<i>INVENTEC</i>	
TITLE	<i>MRT320</i>

Engineer srd01	INVENTEC	
Drawn by srd01		
R&D CHK	TITLE MRT320	
DOC CTRL CHK		
MFG ENGR CHK	VER	
QA CHK		
Model Number	Sheet 12 of 16	Size A3

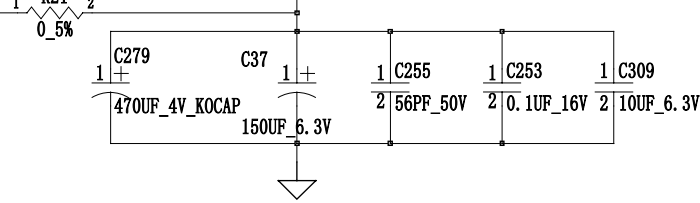
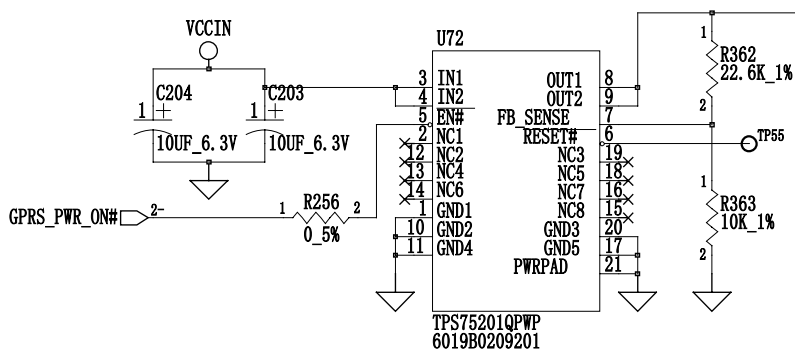
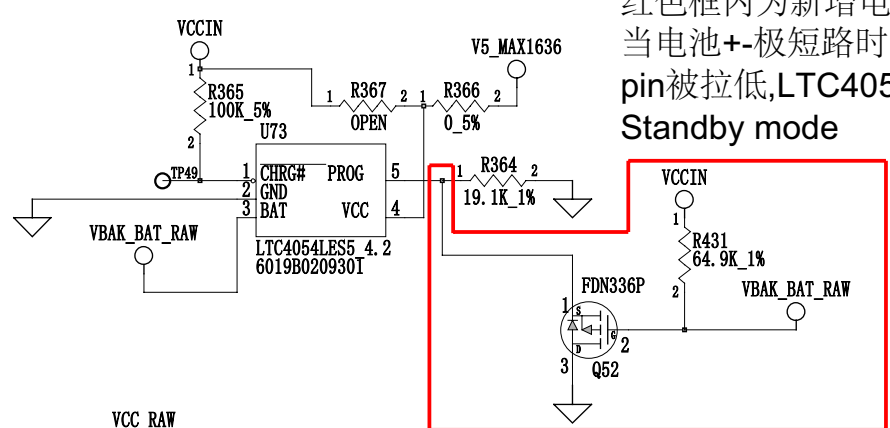
红色框内为新增电路
当电池+-极短路时,PROG
pin被拉低,LTC4054进入
Standby mode

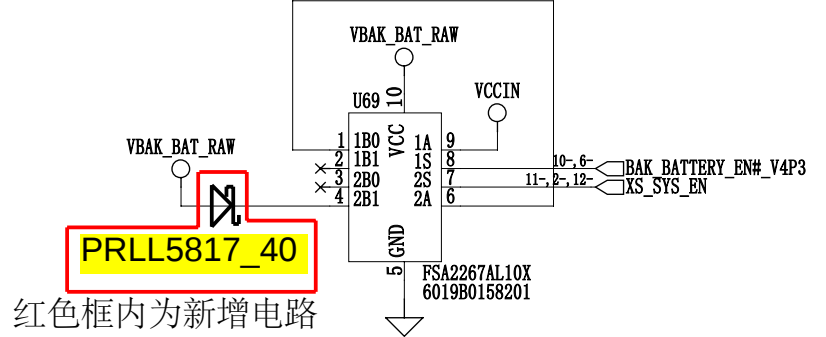
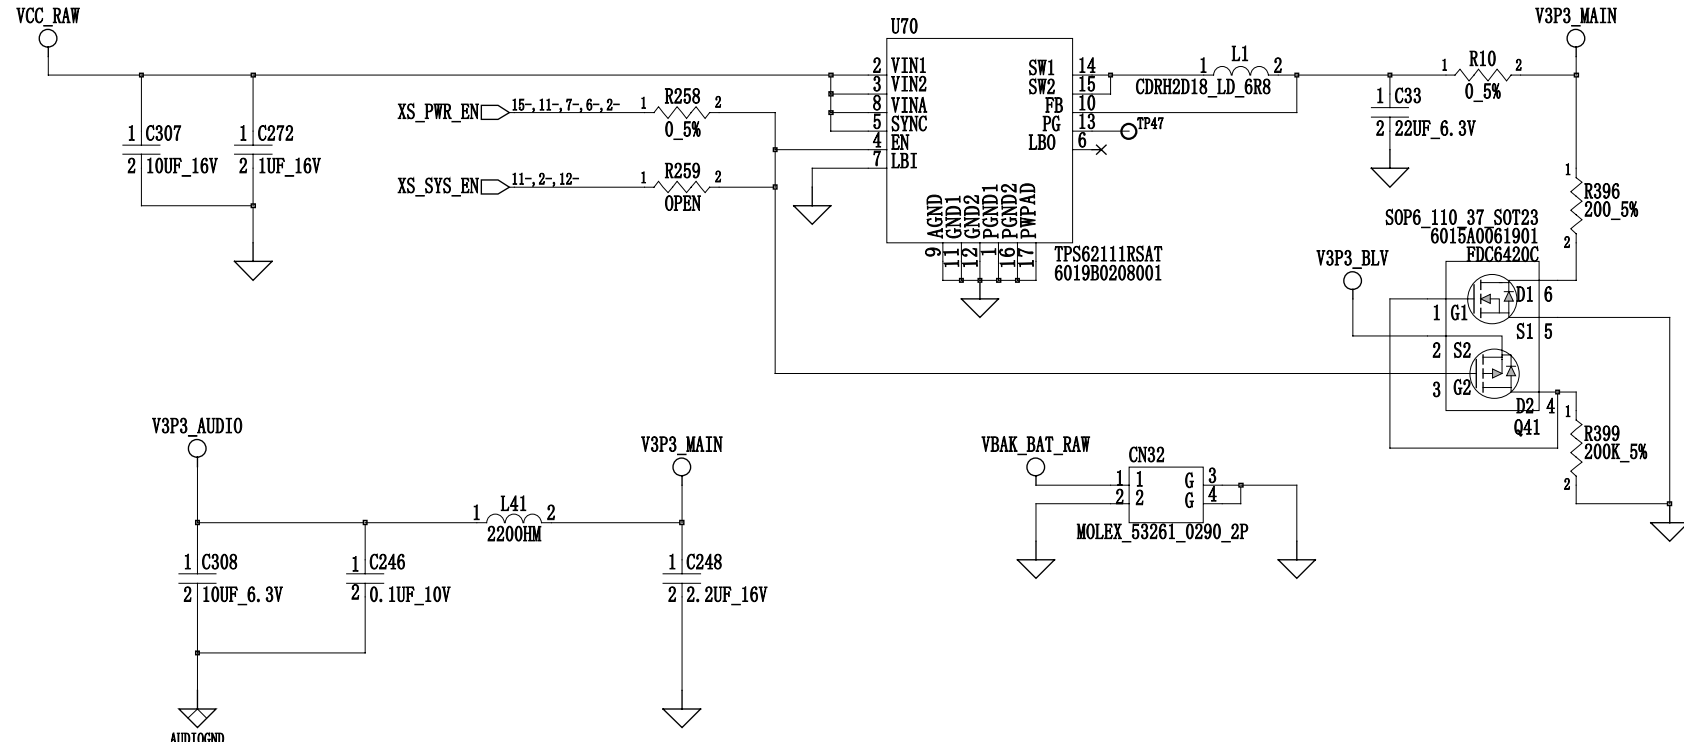
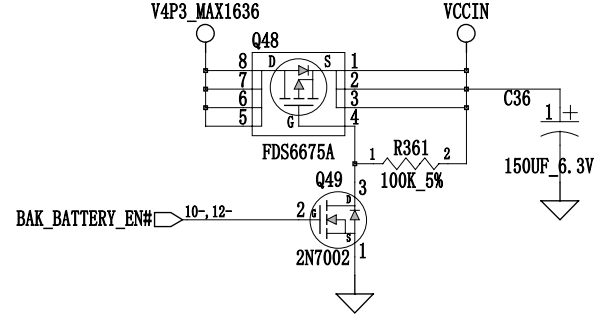
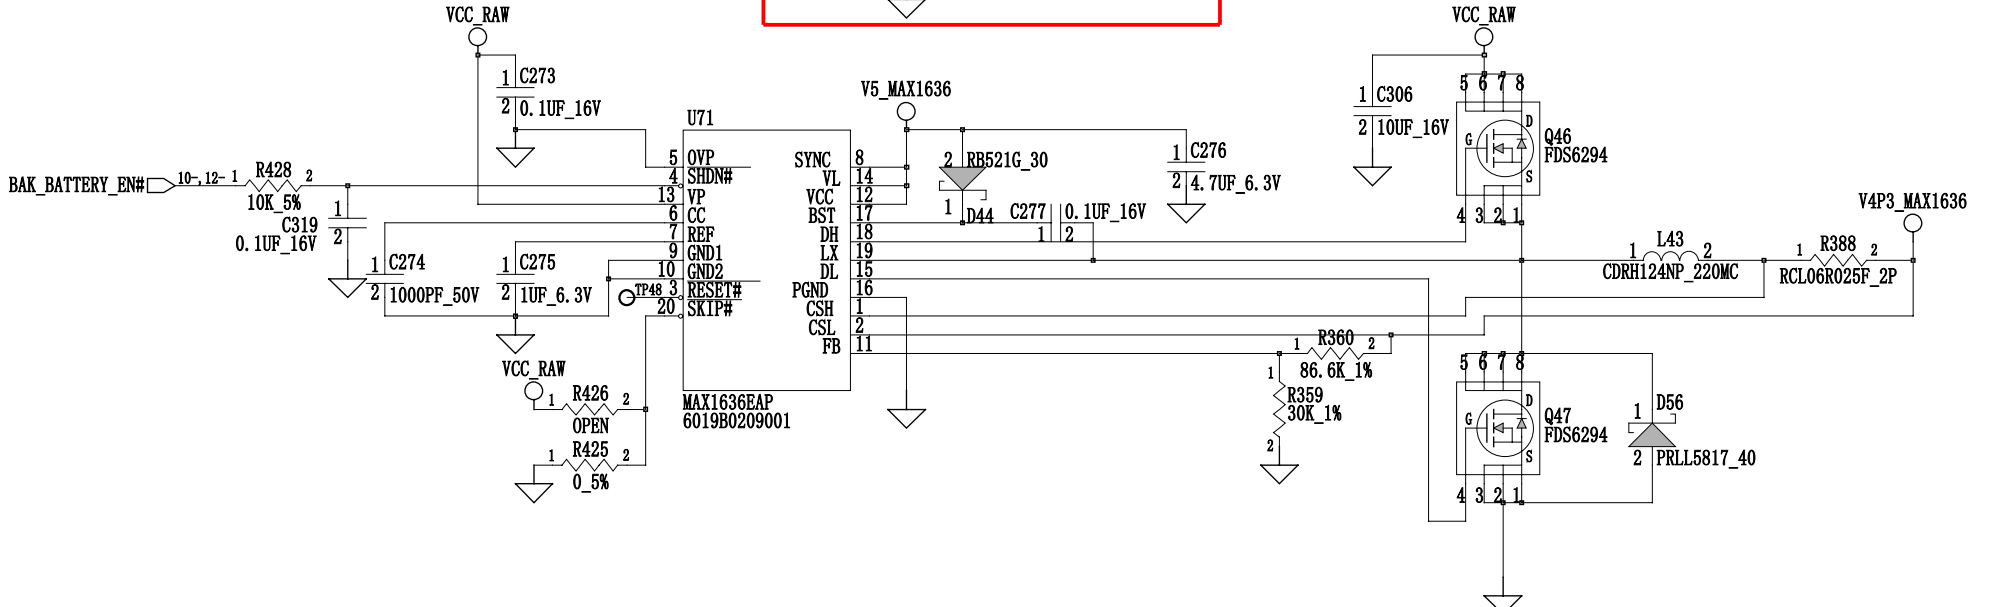
红色框内为新增电路
防止反灌电流
